## **Leachate Treatment Plant Response to Submissions Report**

**October 2017**

Veolia submitted a proposal with the Department of Planning and Environment (DPE) to modify the Woodlawn Bioreactor development approval (DA31-02-99 and MP10\_0012) to include key elements of the LTLM Strategy and notice as follows:

Figure 4.1.1- plan showing nearest sensitive receivers

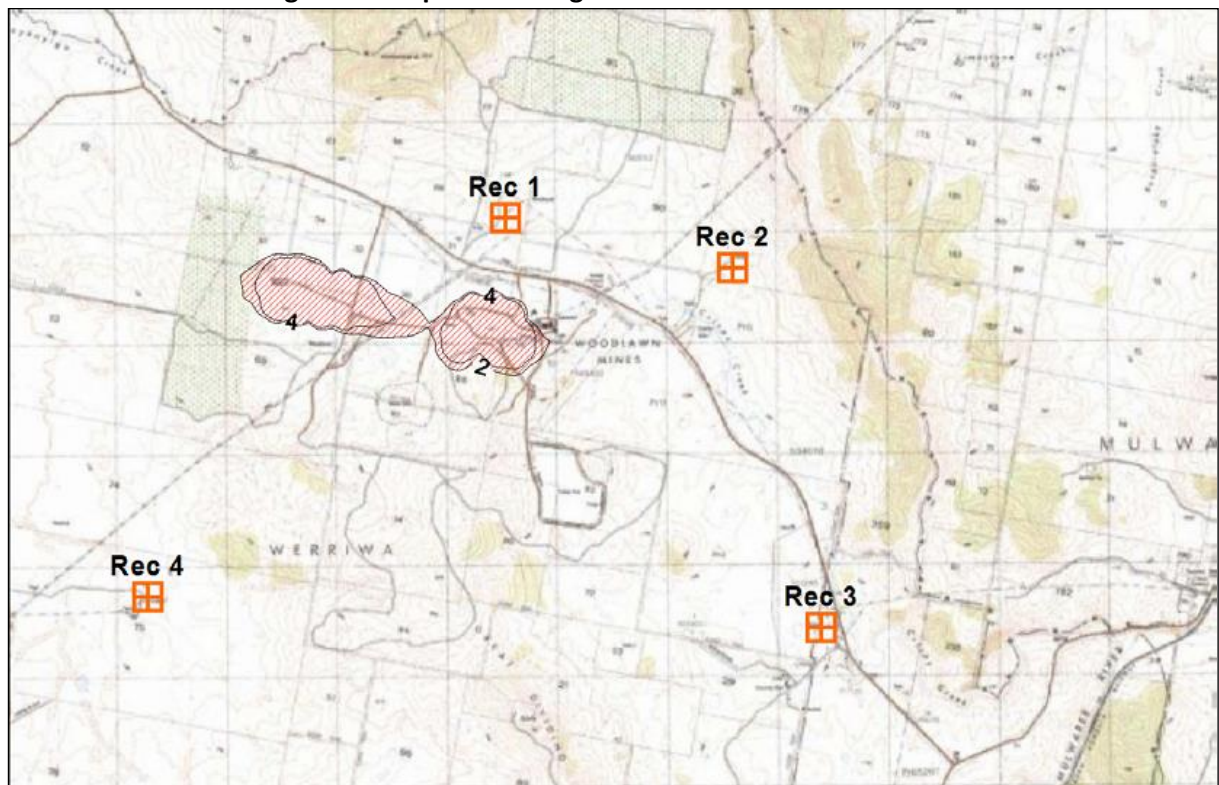
Comments	Response	Reference										
	‘Project-related’ residences. However, in the interests of minimising odour and dust impacts on the surrounding area, the odour and dust impact from both current and proposed project operations have been assessed at all surrounding residences, including ‘Project-related’ residences.	Report										
17. Please confirm whether the odour modelling considered the cumulative impacts from the coffer dam and ED1.	The odour modelling is consistent with the proposed modification as presented in this response to submissions report.	Section 4.2.1 of the Environmental assessment report for the proposed modification										
18. Please detail how many odour complaints were lodged in 2014, 2015, 2016 and 2017.	The number of odour complaints received over the past four years is provided below:

<p>Discussed proposed strategy with Water NSW, including removing addendum from modification and separation of water types within ED1, with newly lined ED1 Cofferdam minimising the chance of off-site water quality impacts.</p> <p>Also discussed the effluent criteria from a long term water quality perspective, as Woodlawn will still remain zero discharge site.</p>	Parameter	Units	Maximum	pH	--	6.5-8.5	Conductivity	µS/cm	--	COD	mg/L	2,500	BOD	mg/L	10	Total Phosphorus	mg/L	13	Ammonia	mg/L	10	Nitrate	mg/L	<1,500	TSS	mg/L	5	TDS	mg/L	30,000	Chloride	mg/L	5,000	<p>Environmental Assessment report</p> <p>Veolia letter to EPA dated 5 September 2017 (Appendix C1 of this Submission Report)</p>
Parameter	Units	Maximum																																	
pH	--	6.5-8.5																																	
Conductivity	µS/cm	--																																	
COD	mg/L	2,500																																	
BOD	mg/L	10																																	
Total Phosphorus	mg/L	13																																	
Ammonia	mg/L	10																																	
Nitrate	mg/L	<1,500																																	
TSS	mg/L	5																																	
TDS	mg/L	30,000																																	
Chloride	mg/L	5,000																																	
<i>Odour Assessment</i>																																			
16. The odour assessment must clearly illustrate on a plan the nearest sensitive receiver including the type of receiver i.e. resident, school etc.	<p>Figure 4.1.1 and Table 4.2.1 in this Response to Submissions Report provides details of the nearest sensitive receiver.</p> <p>The properties of "Woodlawn", "Cowley Hills" and "Pylara" are all Veolia-owned residences and as such, could be considered to be</p>	<p>Figure 4.1.1 and Table 4.2.1 of this Submission</p>
